Arlington Conservation Commission

Date: Thursday, March 21, 2024

Agenda

On behalf of Arlington Land Realty, LLC (the Applicant), BSC Group, Inc. respectfully presents the attached Planting Plan, Sheet L-100, last revised 03/07/2024, to complete our response to SWCA's peer review report dated March 6, 2024. BSC submitted a proposed Invasive Species Management Plan (ISMP) to the Commission and to SWCA on March 7, 2024. During the public hearing on March 7, we discussed two outstanding SWCA comments regarding plant selections shown on the proposed planting plan. Herein we address these comments and for the record, each of SWCA's final comments.

FILE: \Civil\Drawings\2340700-LM
DWG.:
JOB. NO: 23407.02 SHEET L-100

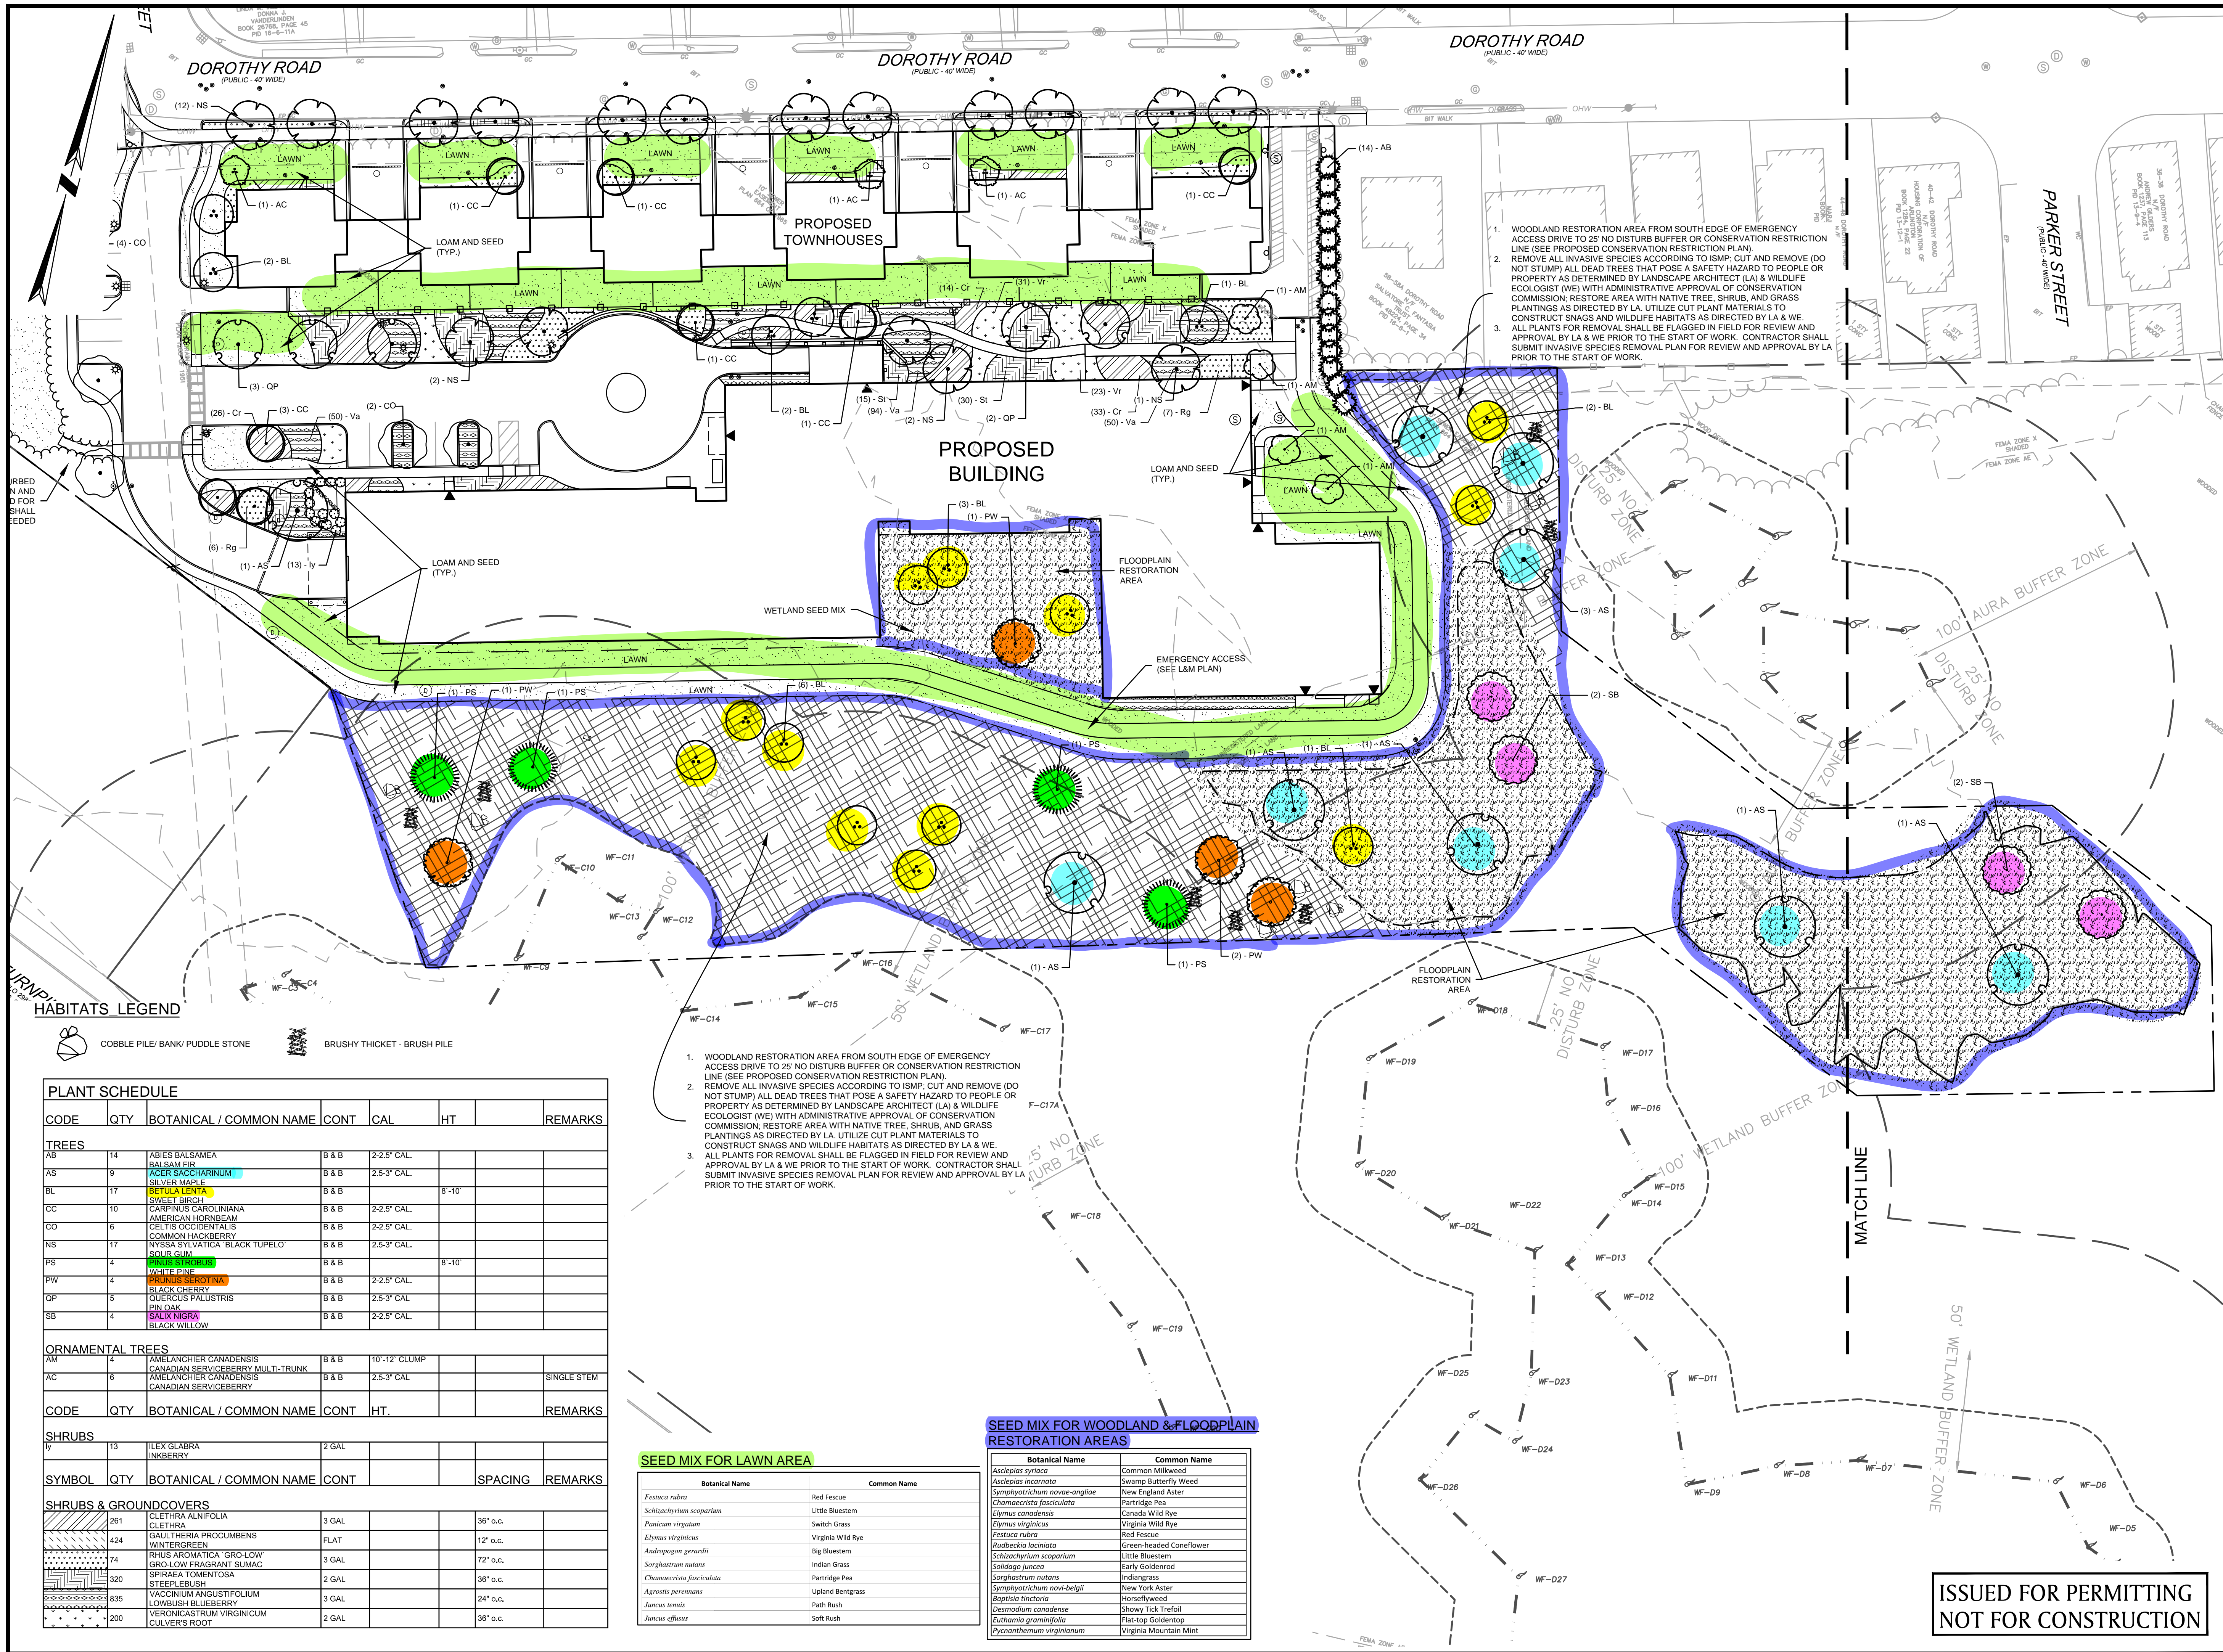
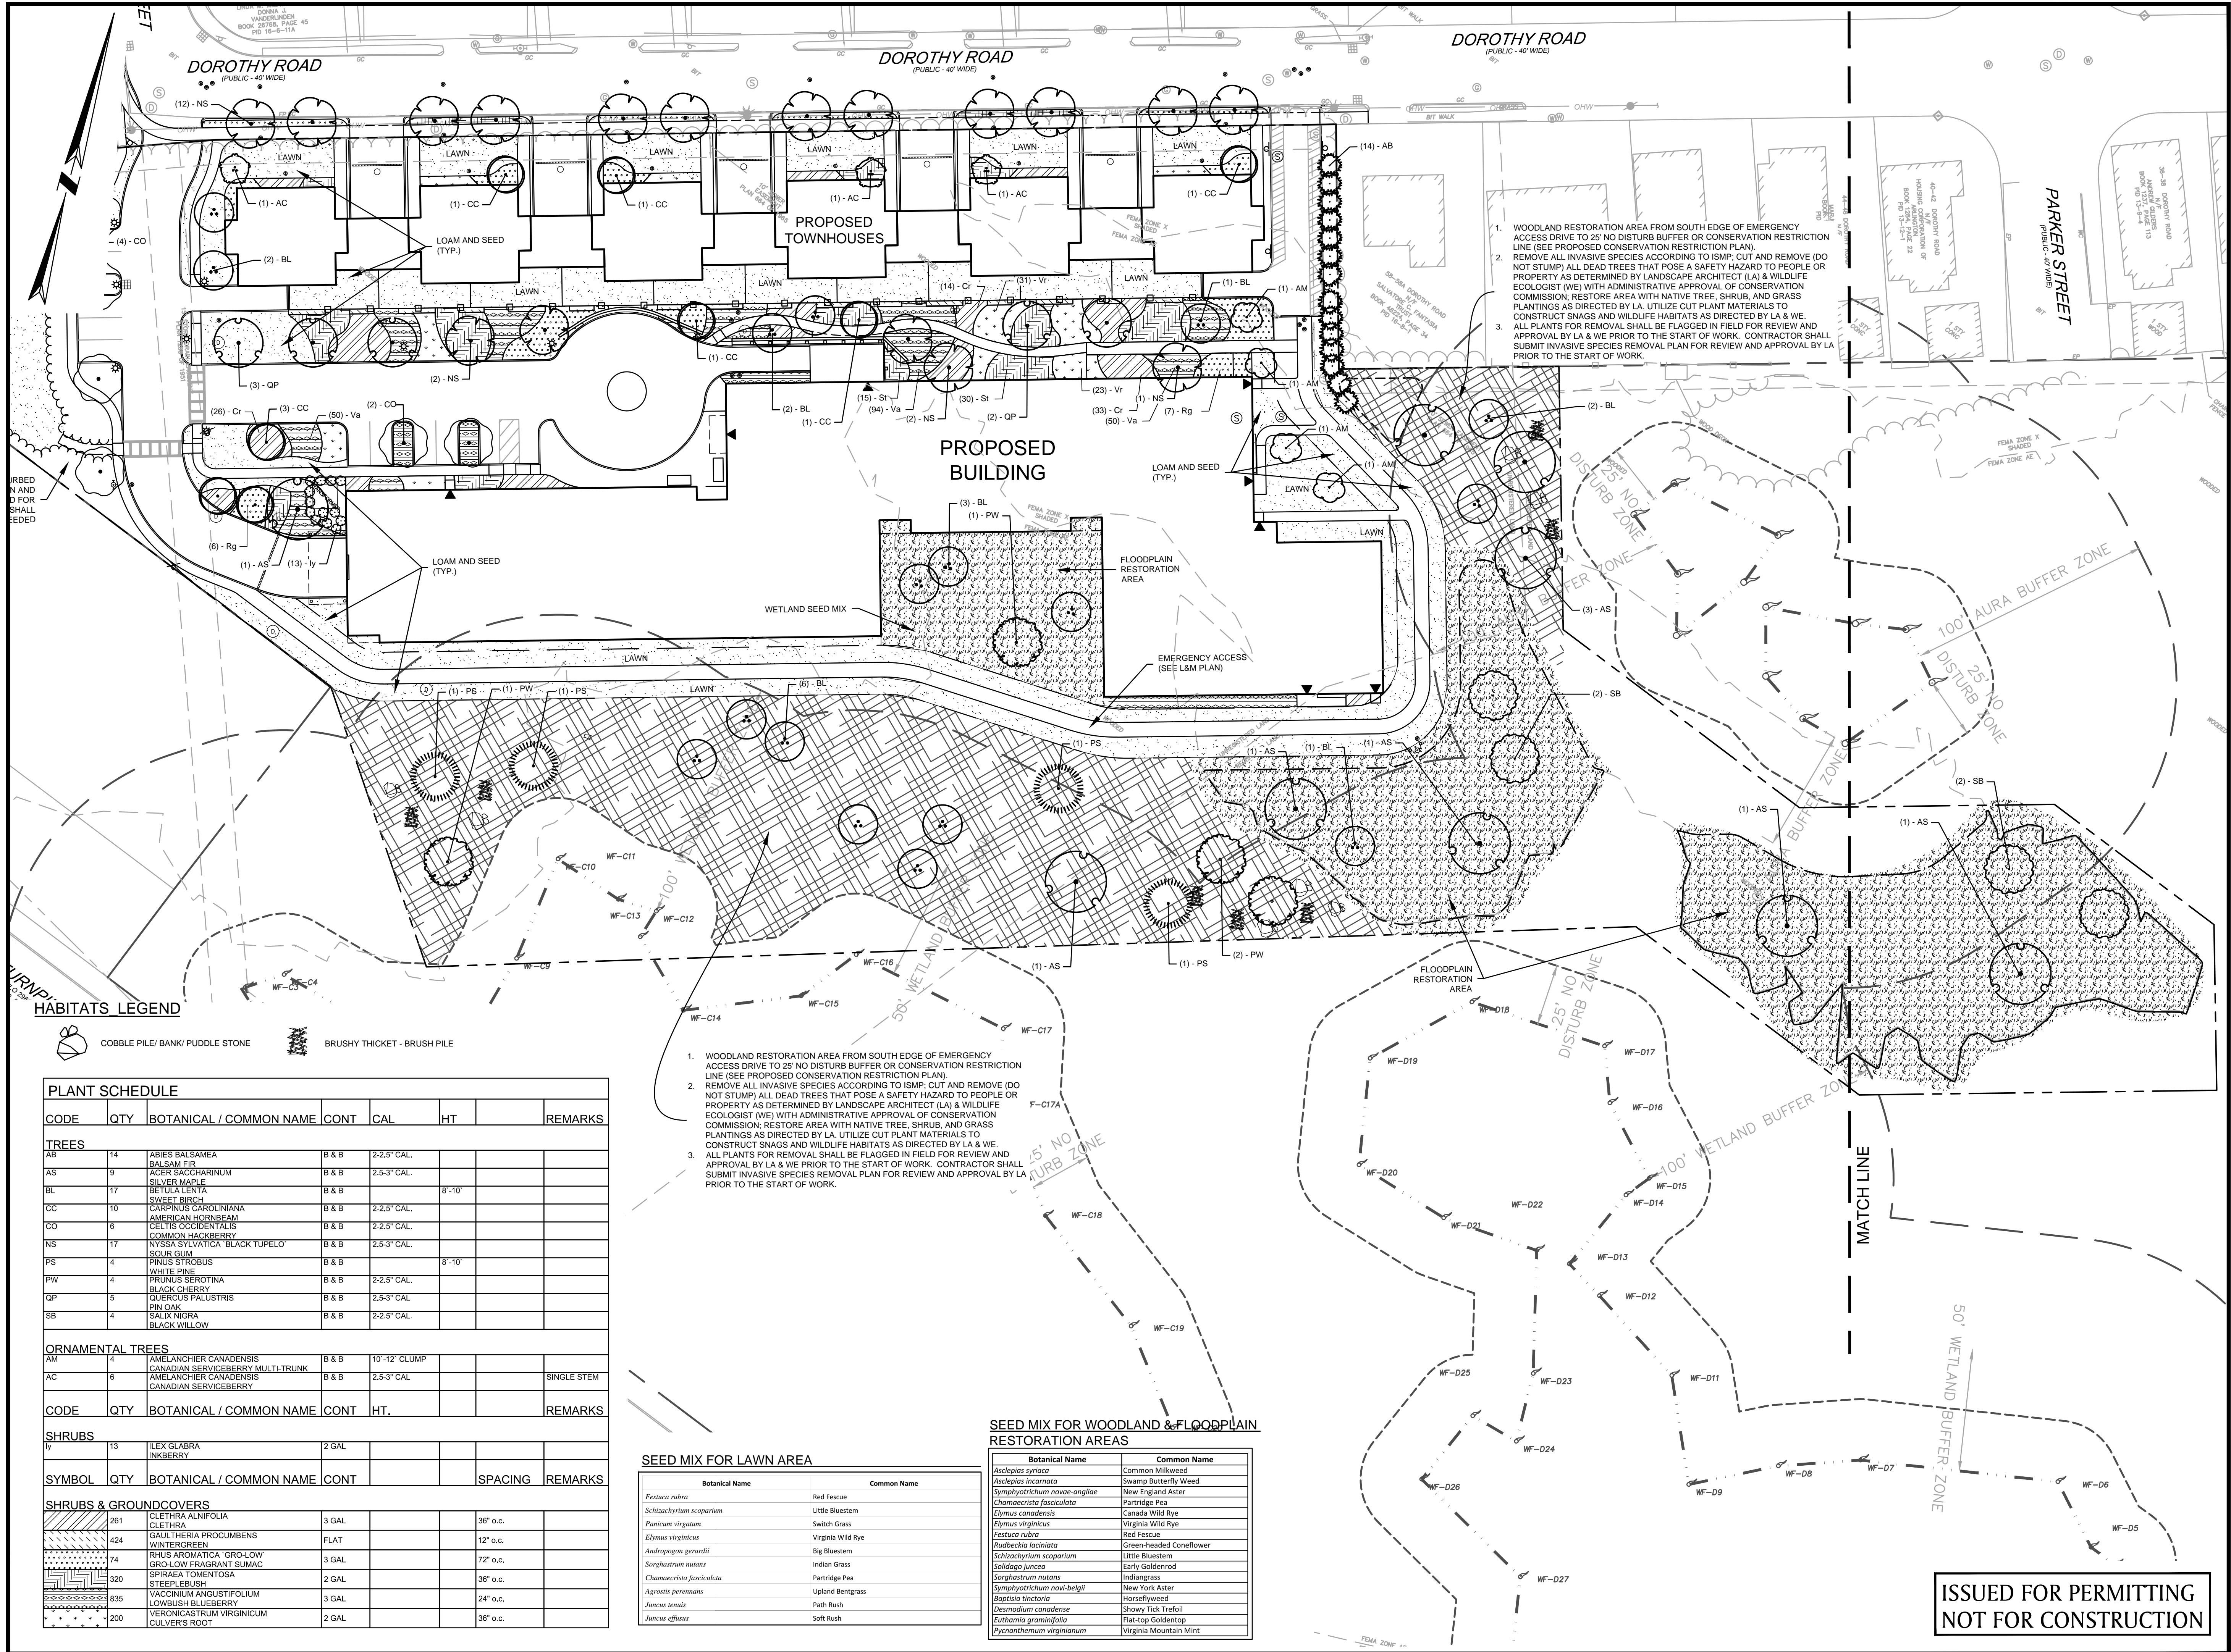
Please refer to the attached Sheet L-100. No tree is proposed *within the restoration area or compensatory flood storage area* that is not specifically listed in SWCA Comment 5. BSC is providing a color-markup of the restoration planting sheet to clarify proposed species placements.

The Note on Sheets L-100 has been updated to state, "2. Remove all invasive species according
